STAFF RECOMMENDATION

418 Bushnell Street
January 20, 2021

Application: Demolition; New Construction—Outbuilding (Detached Accessory Dwelling Unit)
District: Lockeland Springs-East End Neighborhood Conservation Zoning Overlay
Council District: 06
Base Zoning: R6
Map and Parcel Number: 08310011800
Applicant: John Cox
Project Lead: Melissa Sajid, Melissa.sajid@nashville.gov

Description of Project: Application is to demolish an existing outbuilding and to construct a new outbuilding that includes a dwelling unit.

Figures 3 and 4. Proposed front elevation for DADU and historic house at 418 Bushnell Street.

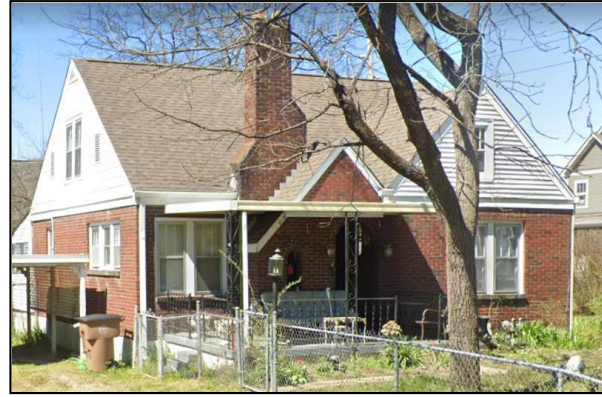
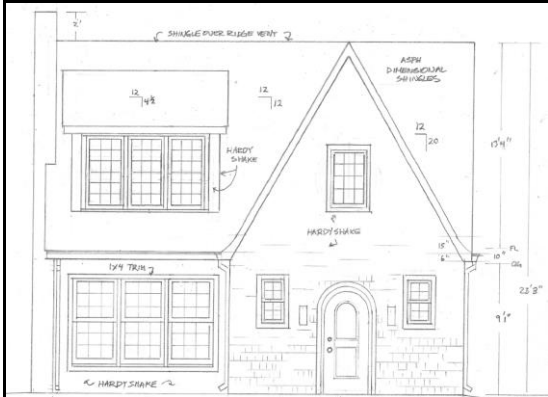
The proposed outbuilding has a Tudor design that the applicant indicates was inspired by a house in Colonial Williamsburg (see plans submitted by applicant). While style is not reviewed, staff finds that the proportions of the design may not be appropriate for an outbuilding in the Lockeland Springs-East End neighborhood and for this lot in particular. As proposed, the second-level floor height is taller than the ground level. While this proportion may not be atypical for this style, these proportions are neither typical of outbuildings nor are they characteristic of the house at 418 Bushnell Street (Figures 3 and 4). The design is not utilitarian, making this proposed building appear as a second primary dwelling rather than an outbuilding. In addition, the height of the DADU exceeds the height of the historic house. Therefore, staff recommends that the height of the second level not exceed the height of the first level and that the overall height of the DADU be reduced so that it is no taller than the historic house. With this condition, staff finds that the design meets Section II.B.8.a of the design guidelines and Section 17.16.030.G.8 of the ordinance.

*As proposed, the ridge height of the DADU exceeds that of the historic house by two and one-half inches (2 1/2"). While the additional height is not a lot, the scale of the outbuilding should not overwhelm the historic house. Staff finds that the combination of the overall height as well as the proportion created by the second floor being taller than the first floor create a scale that overwhelms the historic house and ultimately makes the DADU appear to be a second primary dwelling rather than an accessory to the historic house. Therefore, staff recommends that the height of the second level not exceed the height of the first level and that the overall height of the DADU be reduced so that it is no taller than the historic house.

SITE
COX DADU
10/30/20
REVISED 12/24/20

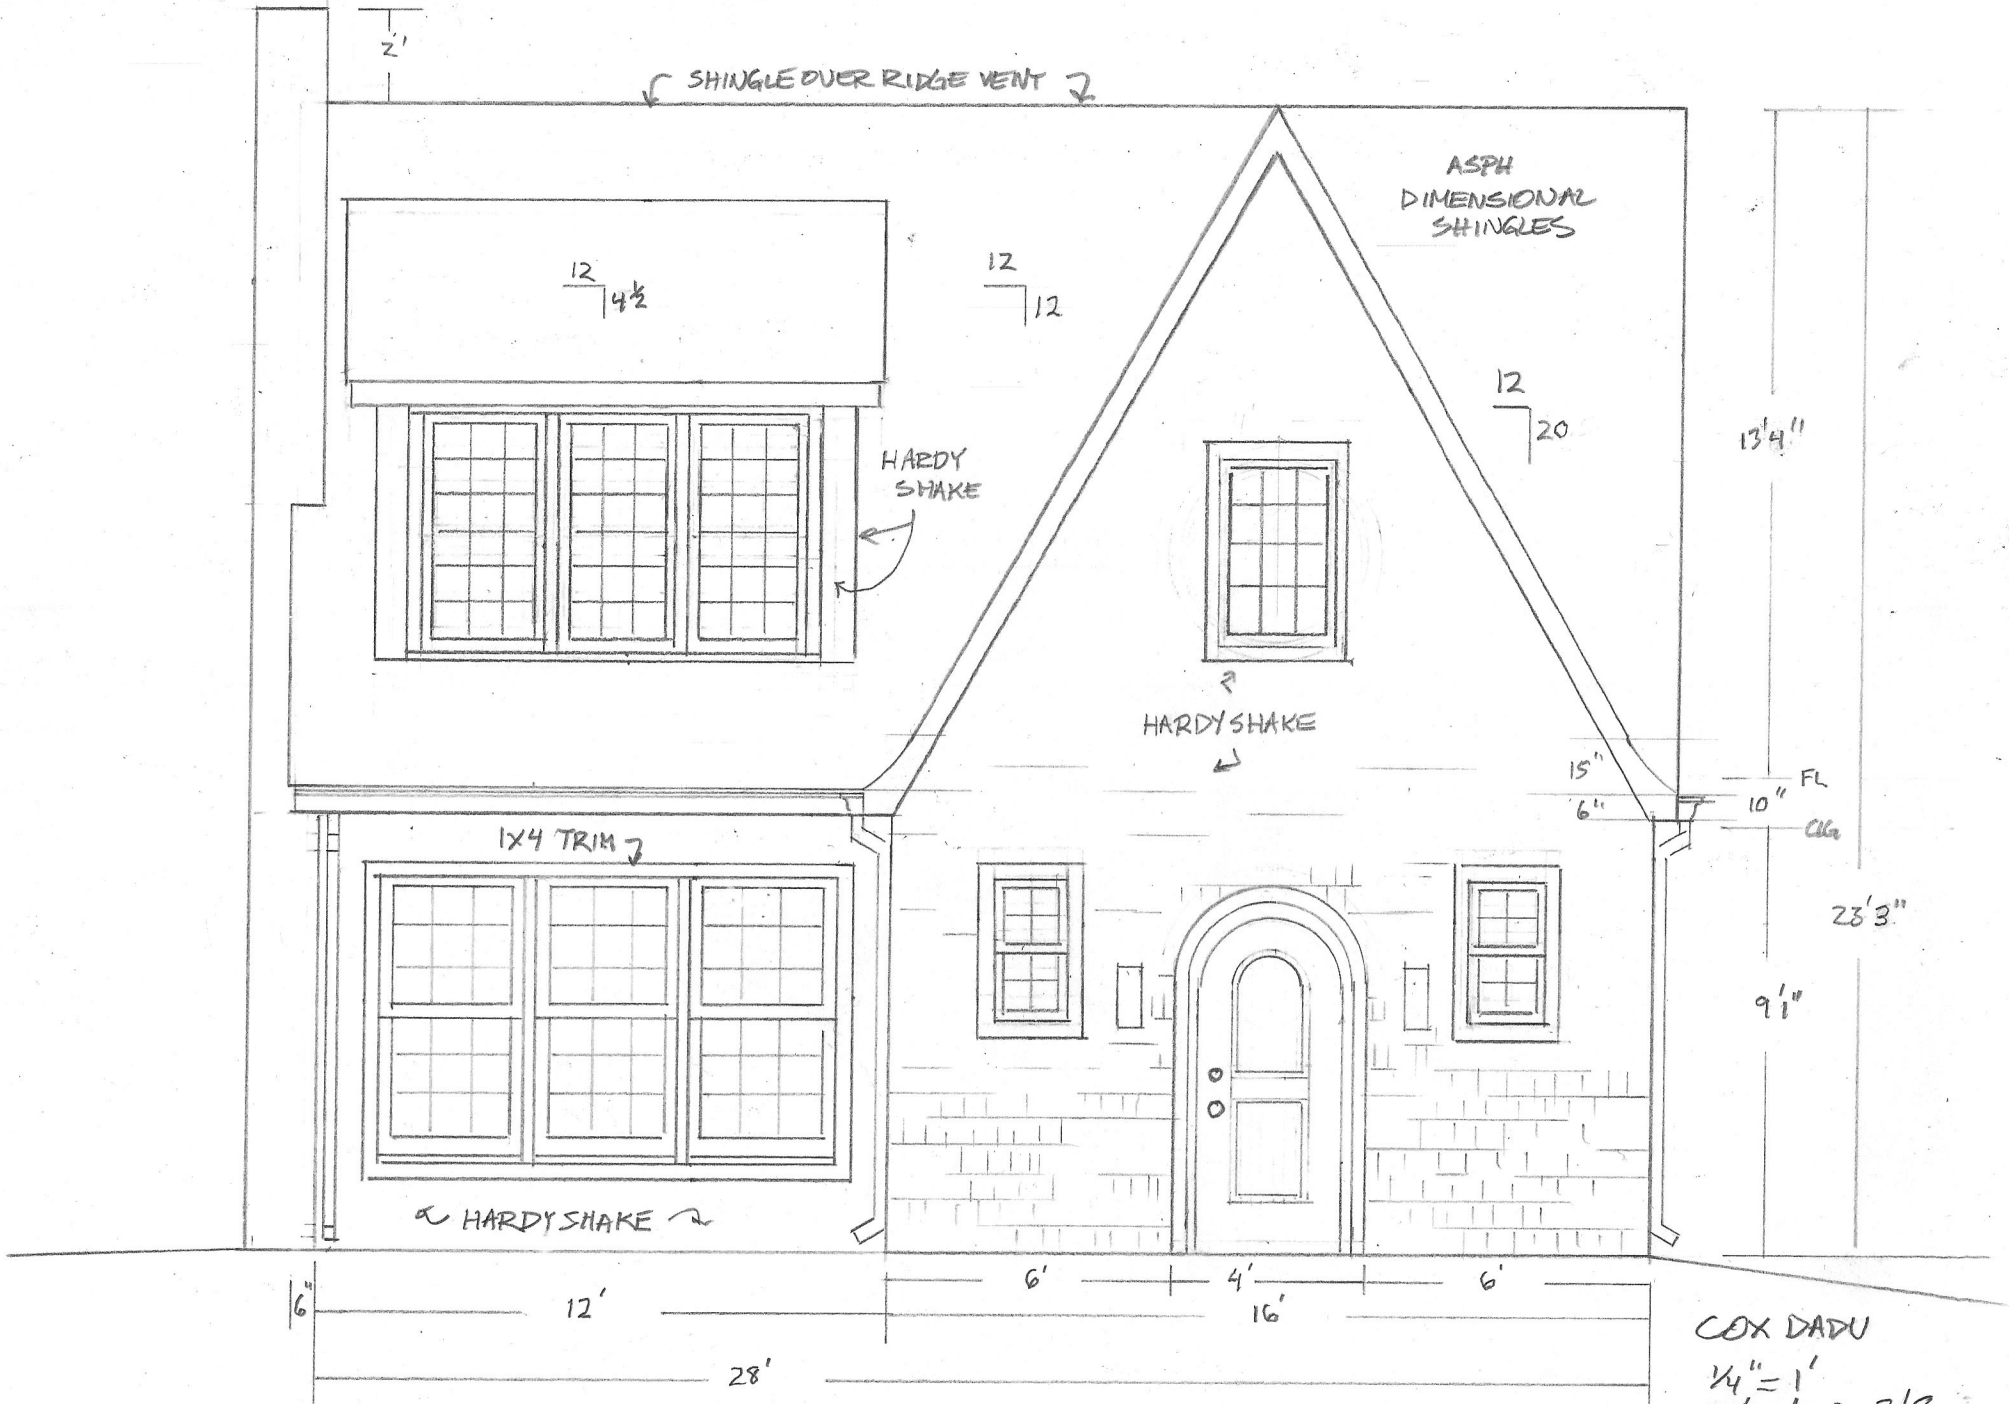
The outbuilding will be located in the same location as the previous garage on the lot. As proposed, the DADU is located sixteen feet (16') behind the house. Staff finds that this could be appropriate in this case given that the lot is relatively shallow at one hundred thirty-six feet (136') deep and the house has a deep front setback at fifty feet (50'). In addition, the DADU is offset from the rear of the house, so the full width of the DADU is not located directly behind the house. Vehicular access to the DADU is from a proposed curb cut on McEwan Street, which is appropriate as the alley is unbuilt. Staff finds that the proposed outbuilding meets Section II.B.8 of the design guidelines and 17.16.30.G. 4 of the ordinance.
